Mask Set Errata for Mask 0M45H

This mask set errata applies to the mask 0M45H for these products:

- MC9S08RE16
- MC9S08RE8
- MC9S08RD16
- MC9S08RD8
- MC9S08RC16
- MC9S08RC8

Case 1

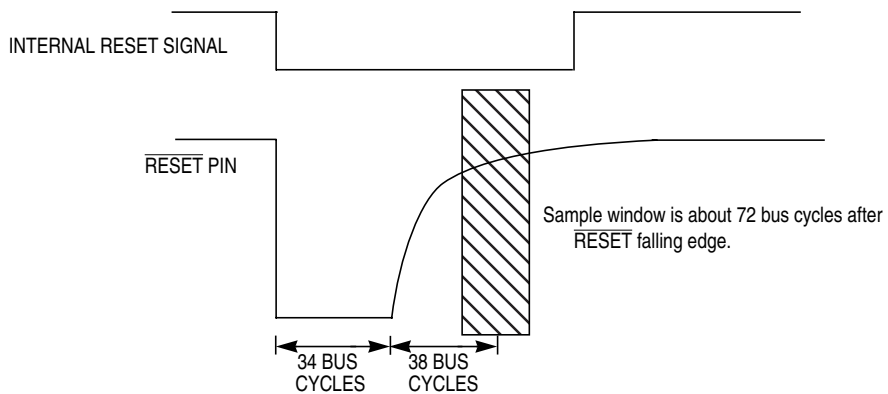
If a falling edge is detected on the external reset pin at either of two sample points, the MCU will cease operation and will recover only after a power-on reset.

Case 1 — After detecting a reset signal, either internal or external, the internal reset circuit latches the cause of the reset, forces a low level on the external $\overline{\text{RESET}}$ pin for about 34 bus cycles, releases the pin, and samples the pin level about 38 bus cycles later.

To avoid multiple edges on the $\overline{\text{RESET}}$ pin due to switch contact ringing or EMC noise, eliminate any voltage bounce through RC filtering. A 0.1 μF capacitor to ground and an external 4.7 k Ω to 10 k Ω resistor to V_{DD} works well to ensure noise suppression.

Case 2

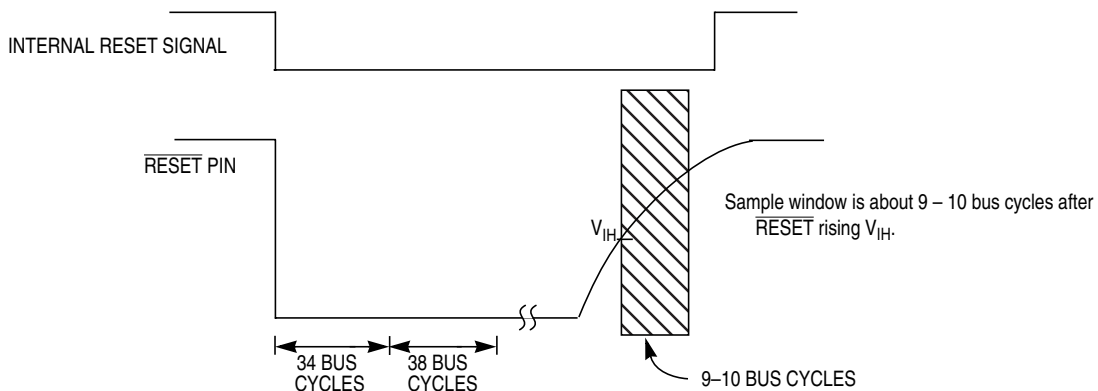
Case 2 — After remaining in reset for an extended period of time due to an externally applied low level on $\overline{\text{RESET}}$, the internal reset circuit will sample the pin level about 9 to 10 bus cycles after the pin raises above its V_{IH} level.

In addition to RC filtering, avoid spurious edges on the $\overline{\text{RESET}}$ pin caused by external active circuitry such as low voltage detectors and watchdog components. Do this by ensuring that external circuitry cannot drive $\overline{\text{RESET}}$ low within 10 bus cycles of the release of $\overline{\text{RESET}}$.
